August 14, 1979

NRC DOCKET 50-366
OPERATING LICENSE NPF-5
EDWIN I. HATCH NUCLEAR PLANT UNIT 2
ADDITIONAL INFORMATION - DIFFERENTIAL BUILDING SETTLEMENT

COMPUTATIONS FOR ALLOWABLE DIFFERENTIAL SETTLEMENT IN TABLE 3.7.8.2-1

FIGURE 2A-16A

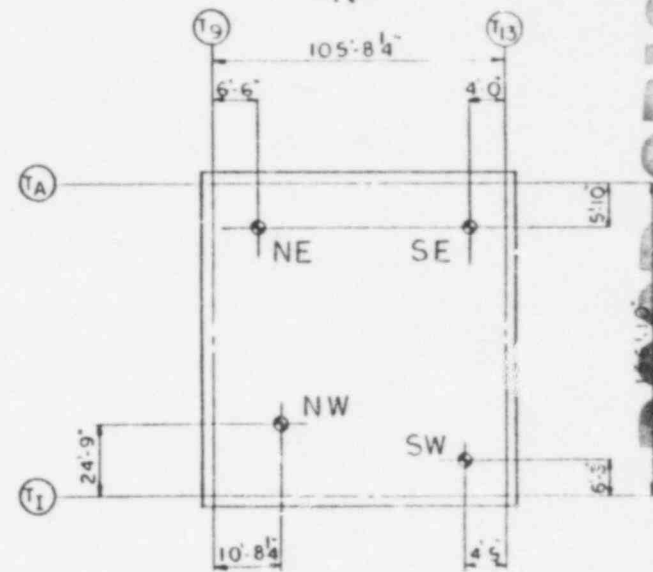
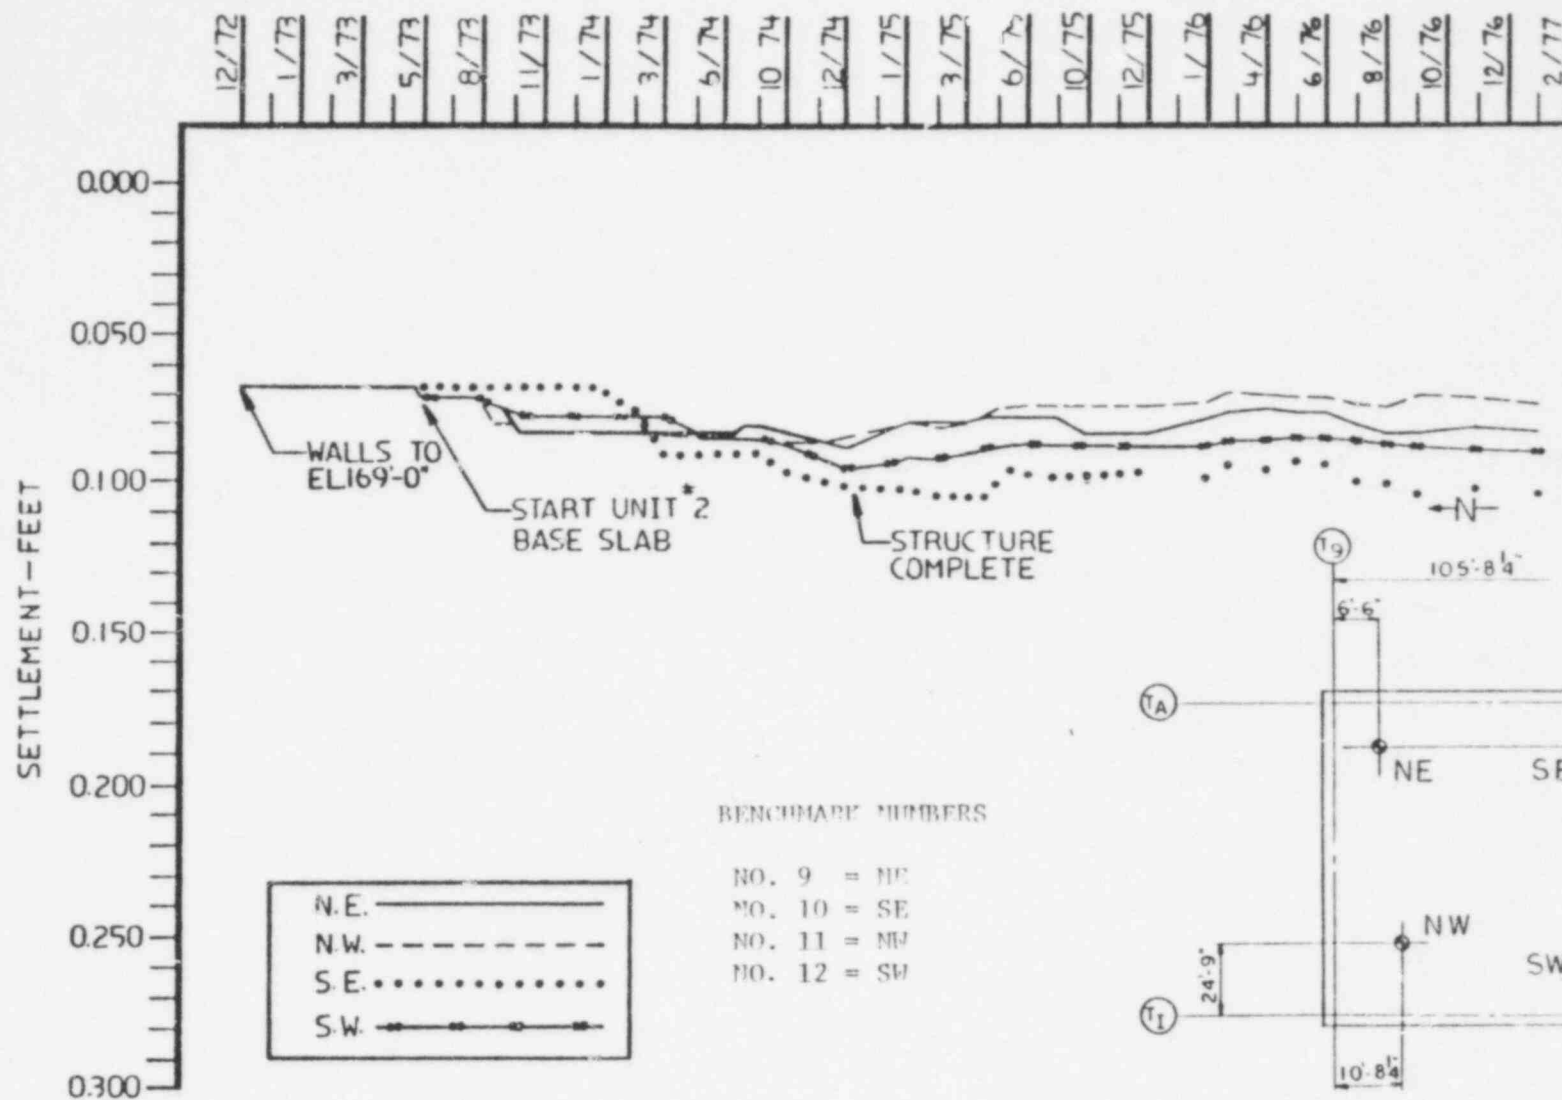
1. Attachment 1 contains revised FSAR figure 2A-16A. The revision provides for a correlation between benchmark numbers used in the proposed Technical Specifications and the FSAR figure.
2. Table 6 of Attachment 2, titled "Summary of Reference Dates and Elevation Across Structures", provides the surveyed elevation for each benchmark and the reference date used for the beginning of differential settlement calculations. Also contained in Attachment 2 is a "Summary of Differential Settlements Across Structures" which provides the results of the comparison of measured to allowable differential settlement. As can be seen from the table, none of the structures are exhibiting any significant differential settlement.

FIGURE 2: UNIT 2 REACTOR AND RADWASTE
BUILDINGS

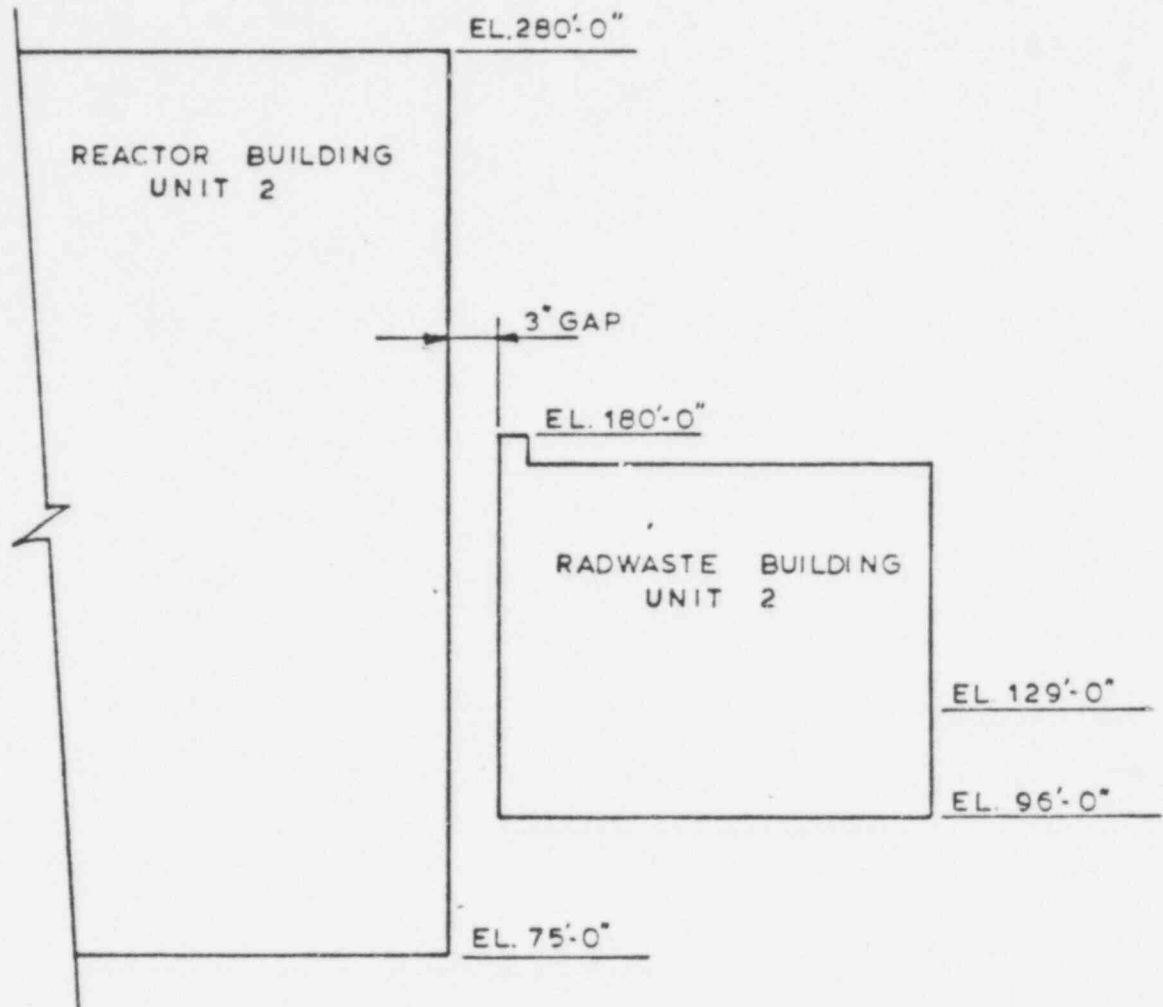
The computational method used for determining the allowable settlement profile slope across structures is illustrated in Figures 2 and 3. The Reactor Building Unit 2 and the Radwaste Building Unit 2 are used for illustration purposes, but the procedure applies to any two adjacent buildings in the powerblock. Once the allowable slope is determined, the allowable differential settlement may be determined using the known distance between benchmarks inside the building. The benchmark locations for the buildings which comprise the powerblock are shown in Figure 1.
